**WHITE LAKE TOWNSHIP
INTER-OFFICE MEMORANDUM
COMMUNITY DEVELOPMENT DEPARTMENT**

SUBJECT: 9101 Highland Rezoning Request

RE: 9101 Highland Road-Proposed Commercial Development- Preliminary Site Plan Review – 3rd Review

Our office has performed a Preliminary Site Plan review for the above-mentioned revised plan dated December 20, 2024. The plans were reviewed for feasibility based on general conformance with the Township Engineering Design Standards.

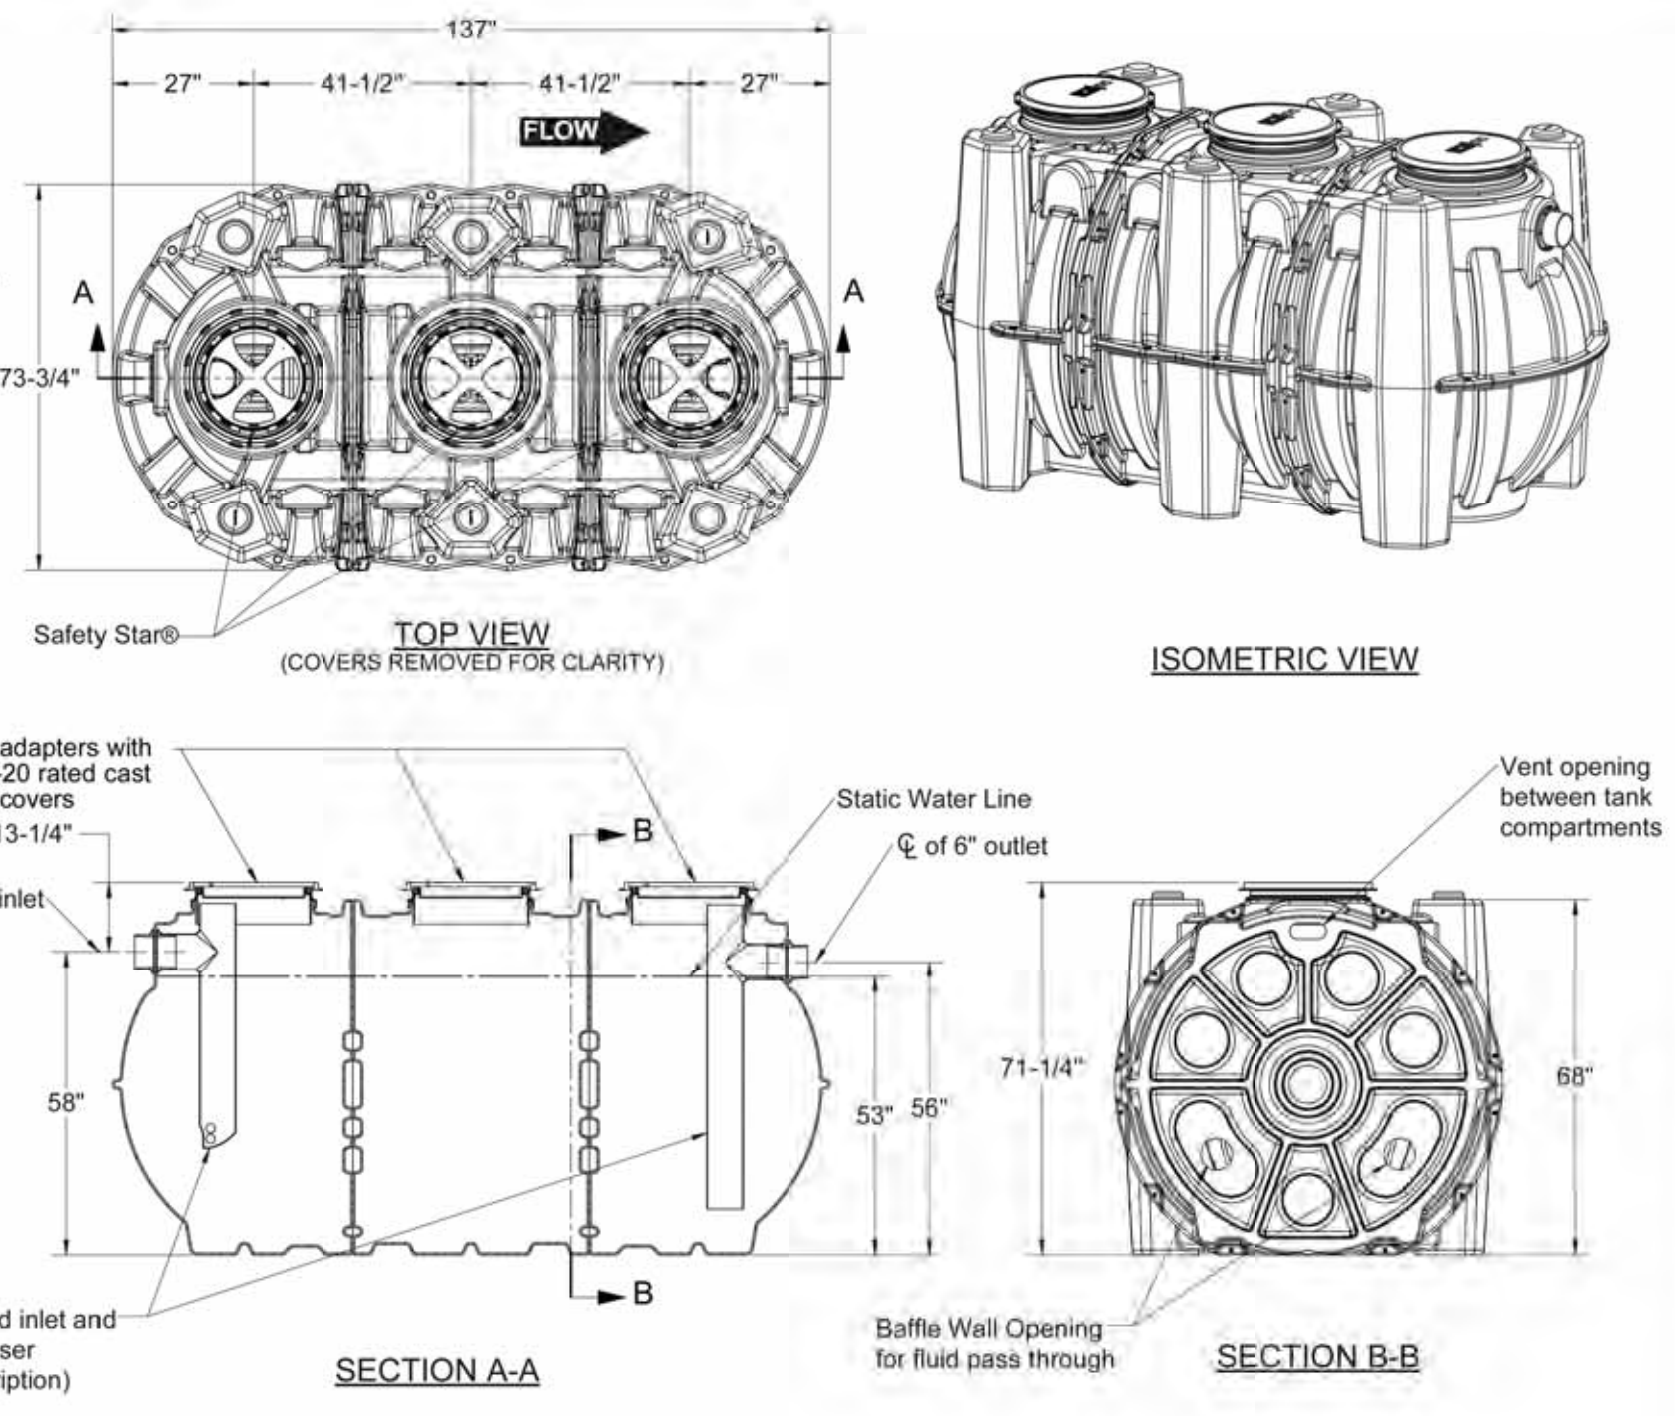
- n) *Sheet C-6- Specify size of the proposed grease interceptor for the westernmost building. A minimum capacity of 1000 gallons is required. Comment outstanding. Although a detail for the GB-75 grease trap has now been provided on plan, it appears that the capacities (liquid-125 gal, grease-118 gal, and solids-31 gal) fall significantly short of the 1000 gallon minimum volume requirement. **Comment addressed. The capacity of the grease interceptor, as well as a schematic(showing acceptable volume) of the proposed grease trap for the westernmost building has now been provided; the interceptor size of 1,500 gallons is acceptable.***

SHEET + NUMBER
A-302

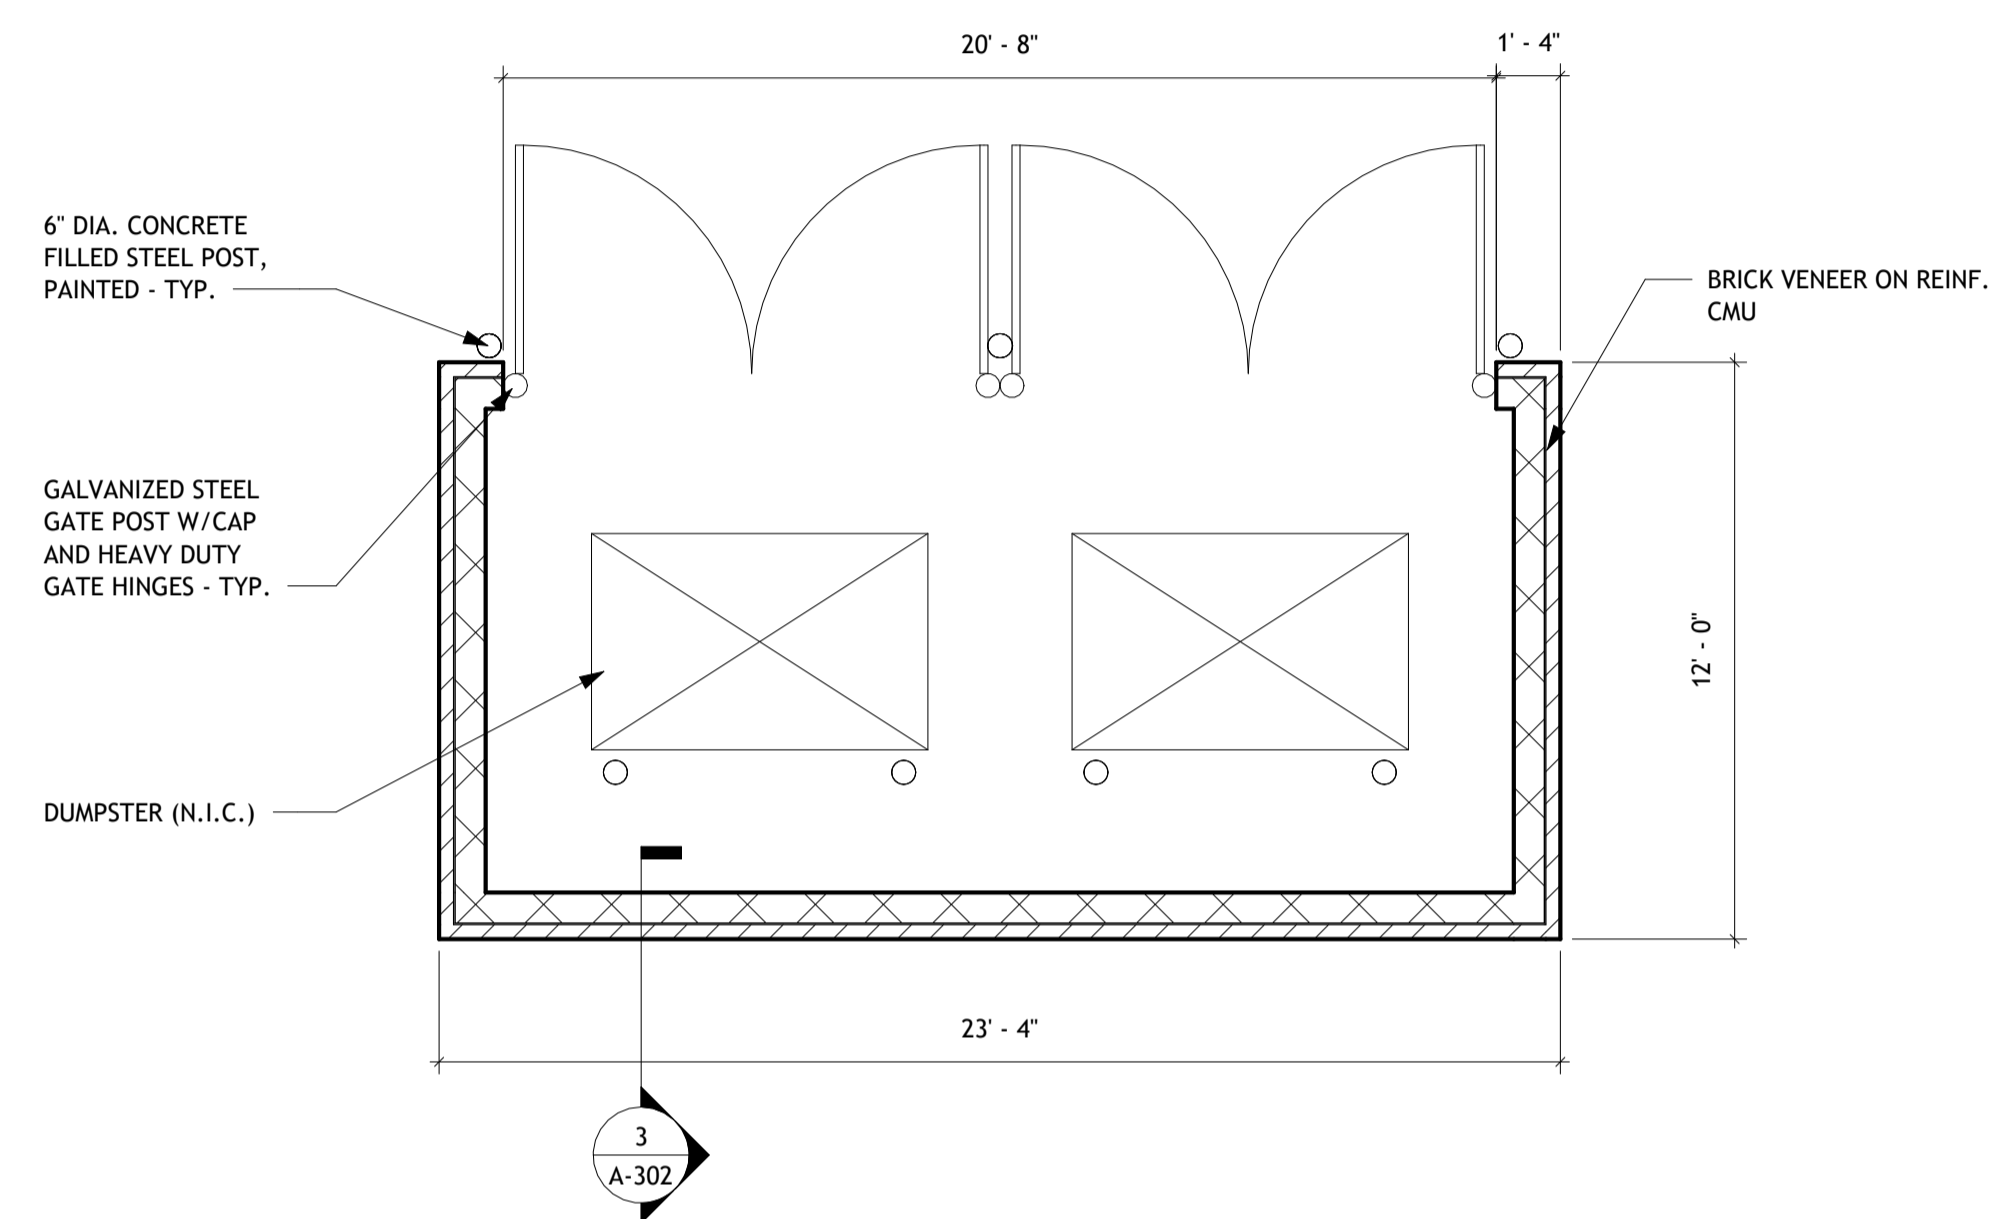
Trash enclosures are to be constructed of similar materials as the principal structure on the site. Brickform concrete or stained, decorative CMU block may be permitted where the principal building is not masonry, however, plain CMU block is not allowed. Details on Sheet C-13 indicate enclosure walls are constructed of split face block CMU but do not indicate a staining or decorative treatment. Sheet A-302 provides enclosure details that reference enclosure walls as CMU and gates materials as stained wooded with a metal frame. The applicant should remove the trash enclosure detail from Sheet C-13 and clarify the CMU enclosure wall decorative feature on Sheet A-302 for final site plan.
